T.I. No.: 2023-18b Updated: 03/10/2023	Subject: Failure of solid-state relays (update)
--	--

Follow up defective solid-state relays

Figure 2: Faulty production lot

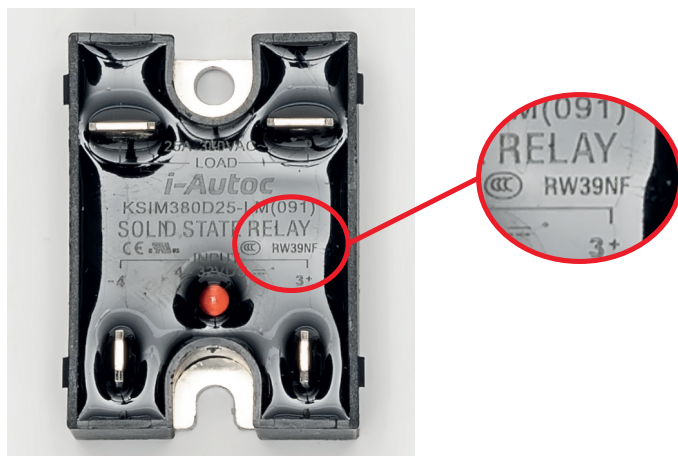
Regretfully, after detailed investigations at our supplier, an additional production lot of solid-state relays has been identified as potentially affected. Next to lot **RW39**, lot **RX14** may have the same faulty component built-in (Varistor). (All other SSR production lots have varistors from a different supplier or a different varistor production lot).

Potentially faulty relays are from the production lots **RW39** and **RX14**. The last two characters (NF in the example) are insignificant, see illustration above.

- ▶ Check the production code of the solid-state relays.
- ▶ If the relays are from the **RW39** or **RX14** production lots: Replace all relays.
